RE: Parkdale Preliminary Plat, PUD Amdt, Site Plan, PP-01058-2019, PUDA-001059-019, SP-001060-2019

RE: REVIEW OF PARKDALE FILING No. 2 (PAIRED HOMES) RESUBMITTAL

Subject: Parkdale – Preliminary Plat 2, PUD Amdt 2 & Site Plan 2

To: Matt Janke – OEO, LLC
From: Audem Gonzales, Planner
Date: November 19, 2019
Re: PP-001058-2019: Parkdale Preliminary Plat No. 2
SP-001060-2019: Parkdale Site Plan No. 3
PUDA-001059-2019: Parkdale Planned Unit Development Amendment No. 2
cc: Fred Starr, Chad Schroeder, Joe Smith, Darren Champion

Sheet L8

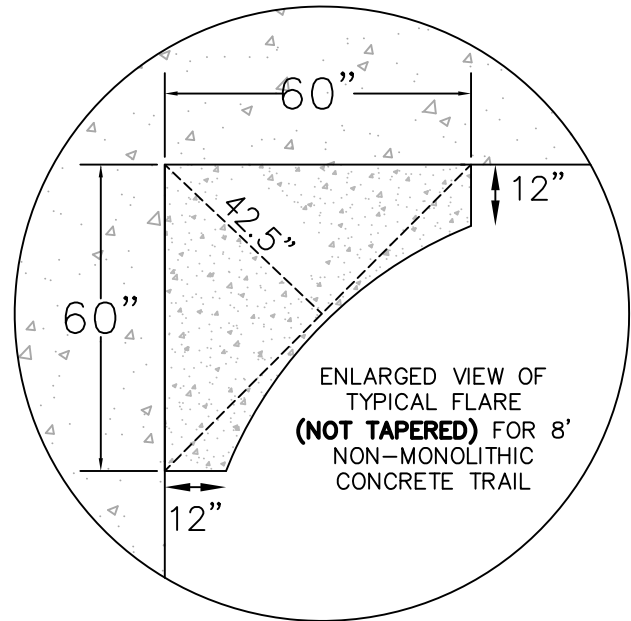
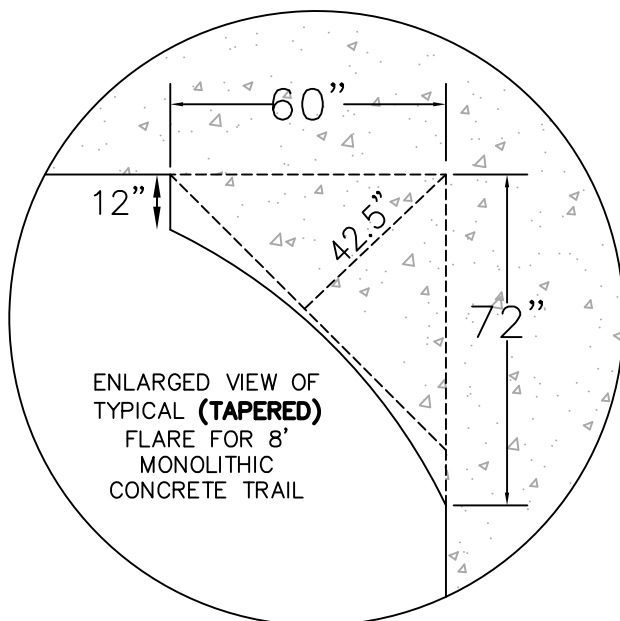
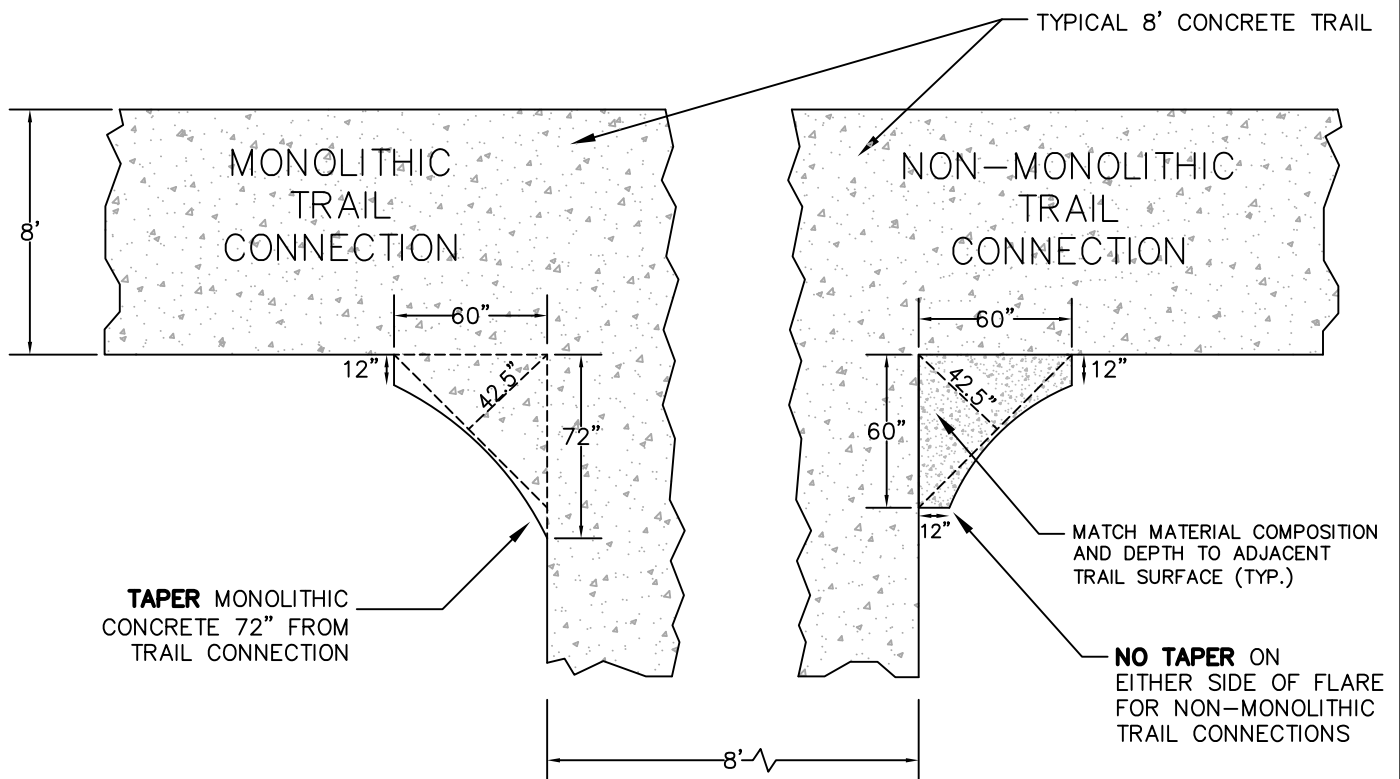
- Center the SW10A style curb ramp to the spine trail where it connects.
- Reduce the sod area located in Tract H and immediately adjacent to the spine trail. Replace with shortgrass native grass seed within the first 10-15 ft. of the crusher fines.
- Add trail stop signs to either side of Road F at the point where the spine trail crosses.

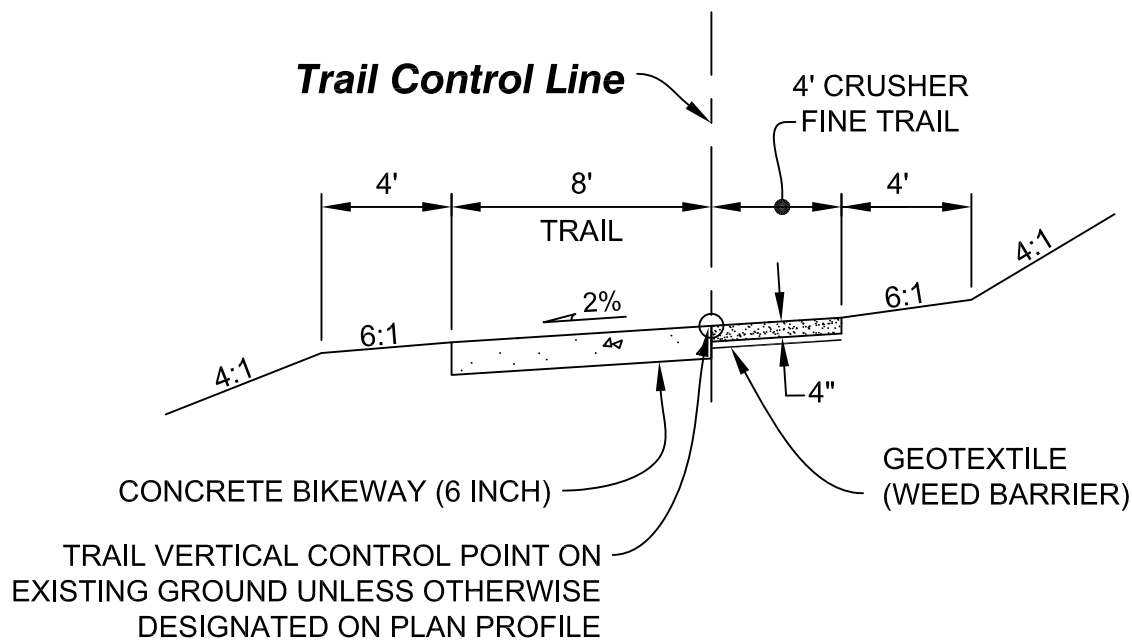
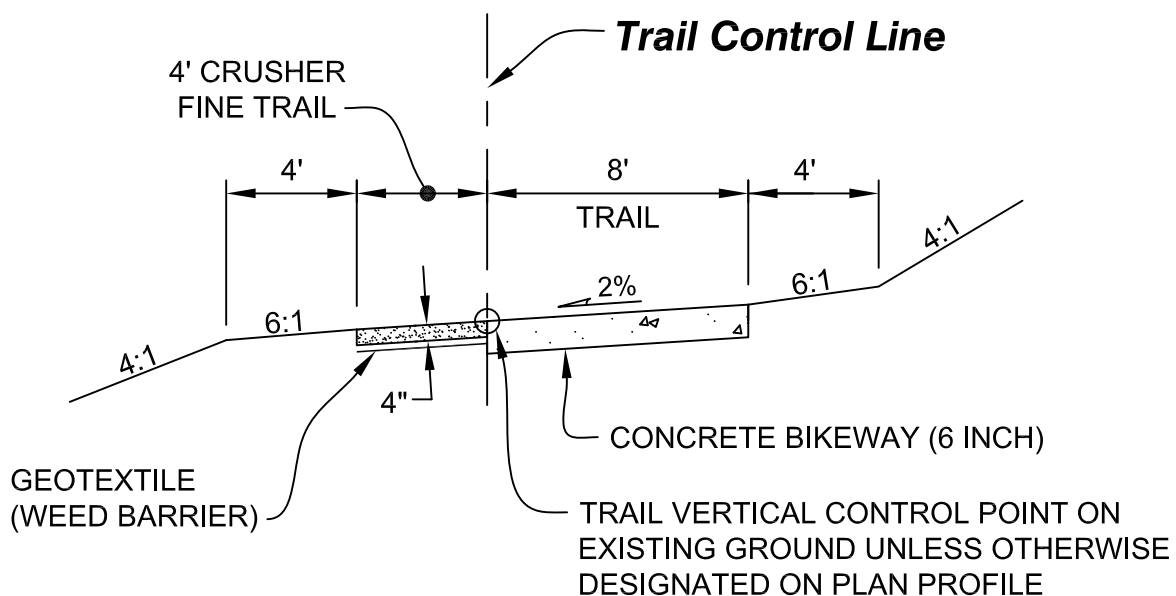
- Add the P25 spine trail design detail that is attached below. Please use the typical section that is shown at the top of Detail P25.
- There appears to be a conflict with the following requirement at the intersection of Road A and 119th Street: trees are not to be located within 55 ft. from the point of curb return at road intersections where a stop sign is present.

Sheet L4

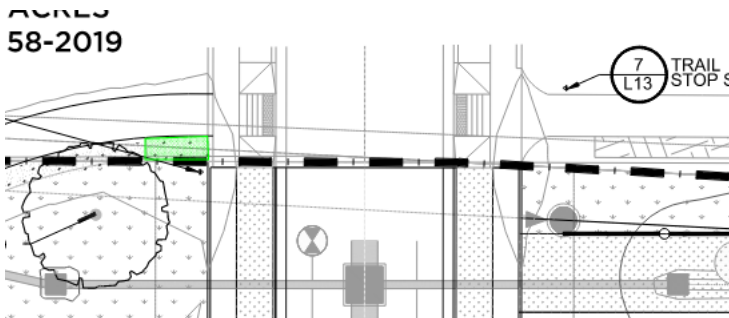
- There are several issues with the current vehicle trail access off 119th St., these include trail alignment, street light placement, and a tree placed over the ramp on the landscape plans.
- Provide alternate sketch options for the ramp access off 119th St. Staff would like to see the ramp access remain at a 90 degree offset to 119th St., but the spine trail must have a direct access from the curb ramp. Staff will work with the applicant and Engineering to review the sketch options and find an acceptable solution.

Sheet L2

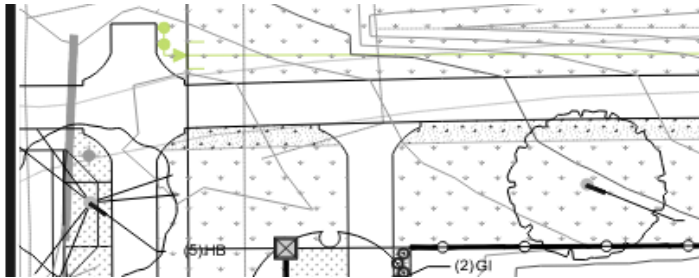
3. The incorrect native seed mixture is shown. Replace with the Table 2 Shortgrass Prairie Native Seed Mixture that can be found on Page 1000-25 of the Town of Erie Standards and Specifications. The standards and specifications can be found at the following link:
<https://www.erieco.gov/DocumentCenter/View/10043/Section-1000---2021-Parks-Construction?bidId=>

Sheet L8

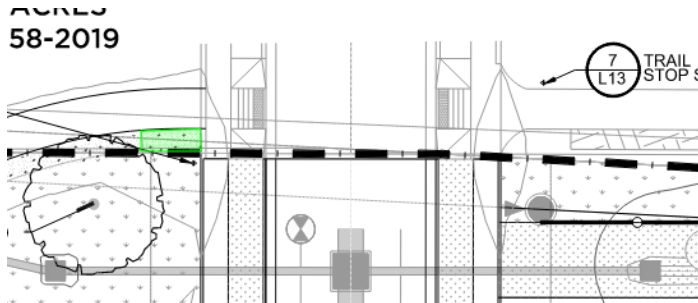
6. Stop the crusher fines approximately 15-20' prior to the curb ramp. Change the area highlighted in green to short grass native to match the east side of the road.

- 6.1. **Applicant** - The crusher fines hatch has been revised.
- 6.2. **Response** - Please remove all crusher fines references from the plan set per comment #2.
